Detailed Site Plan Melford Property Pod 6

DSP-07031-05

STAFF REPORT

SUBJECT: Detailed Site Plan DSP-07031-05
Type II Tree Conservation Plan TCPII-036-99-19
Melford Property Pod 6

TYPE II TREE CONSERVATION PLAN

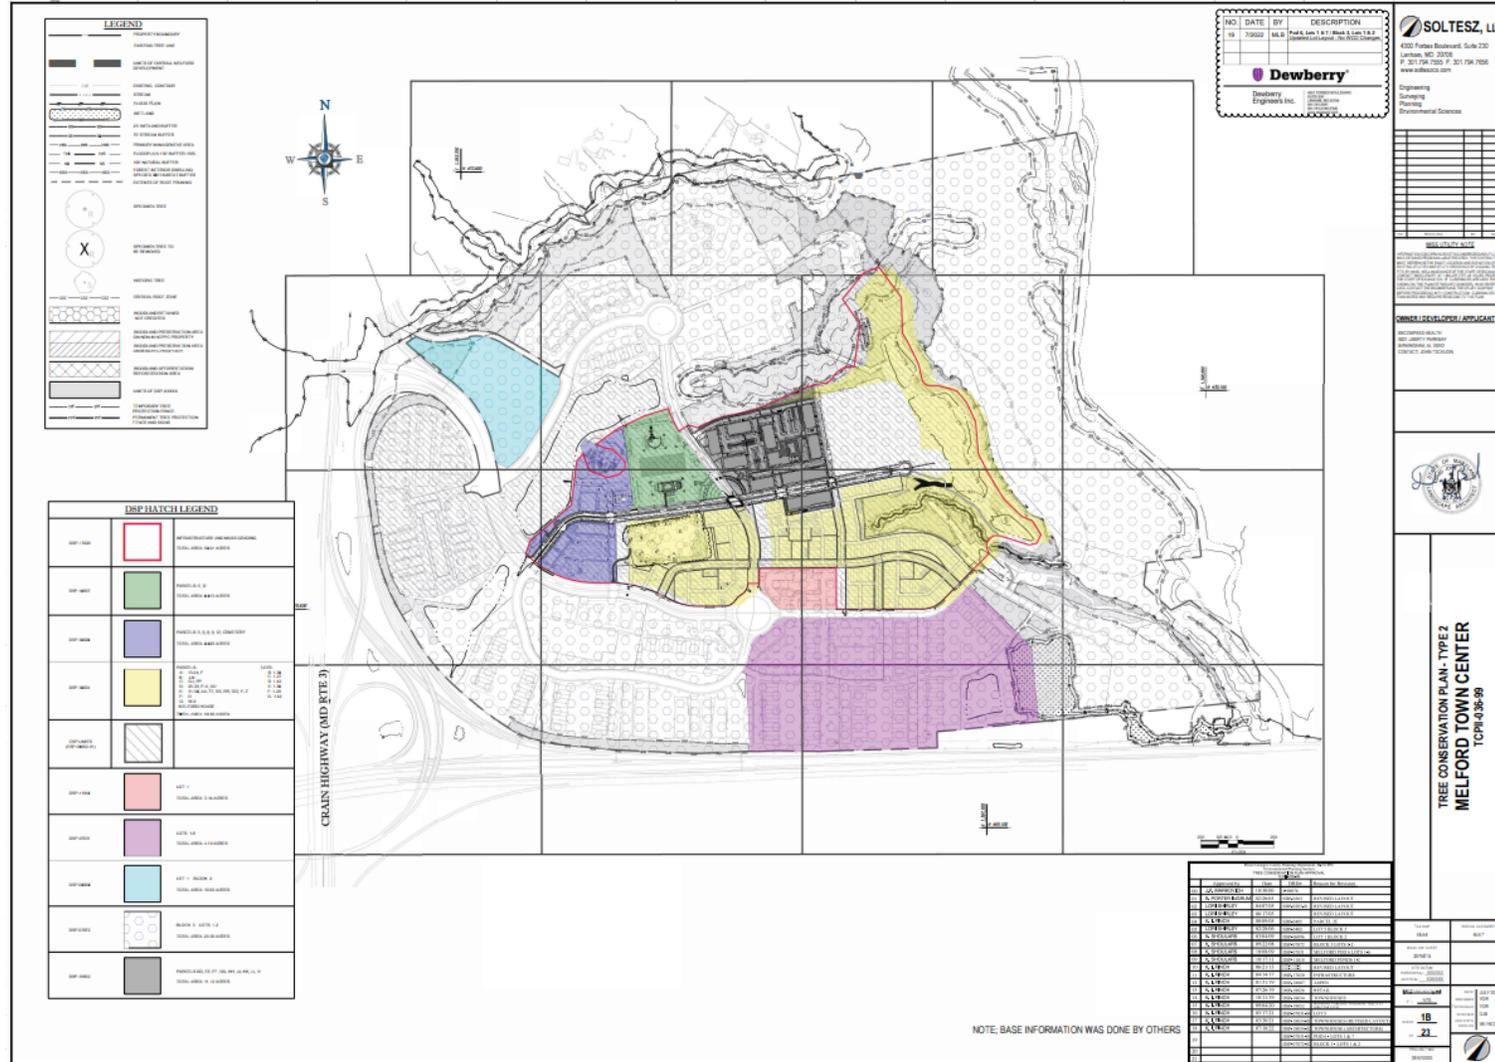
2. Prior to signature approval of the detailed site plan, the Type II tree conservation plan shall be revised to correct the sheet numbering.

TRUCK TURN EXHIBIT – 1

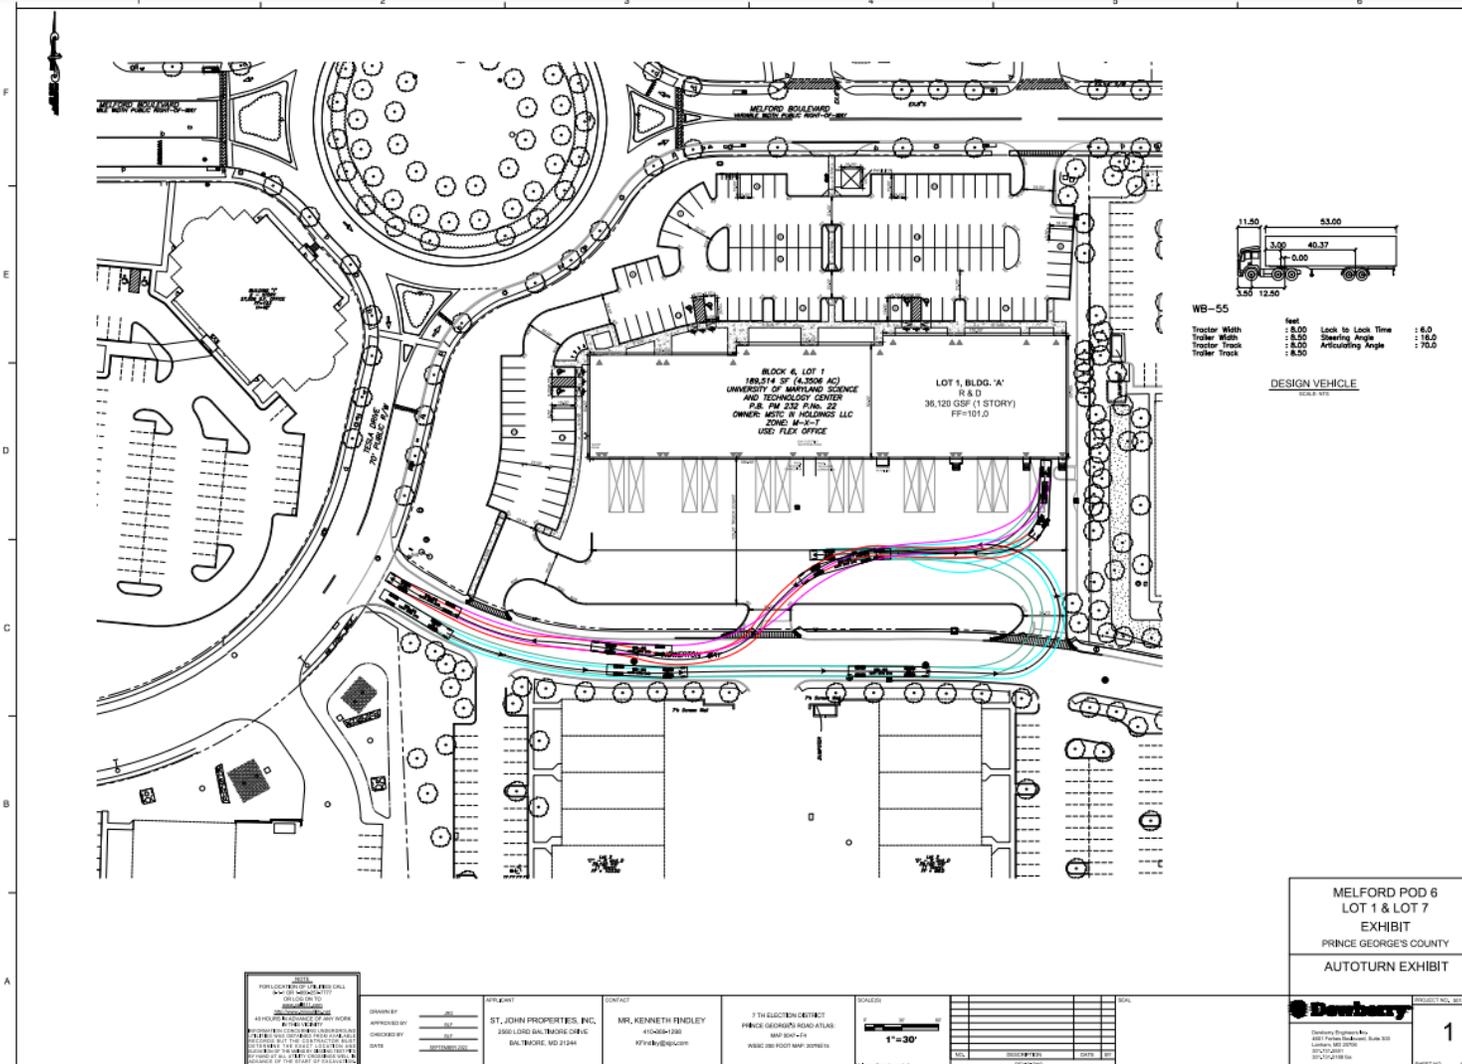
- c. Revise the DSP sheets and the truck turning plans to display the road dimensions and lane configuration of Howerton Way.
 - d. Revise the DSP to close the inter-parcel connection along the southwestern portion of Lot 1, thereby separating the truck court from the surface parking area.

- e. Provide an additional truck turning plan that shows truck turning movements and access to Lot 7. The exact design and truck turning plan, with design vehicle classification, shall be evaluated and accepted by the Transportation Planning Section.
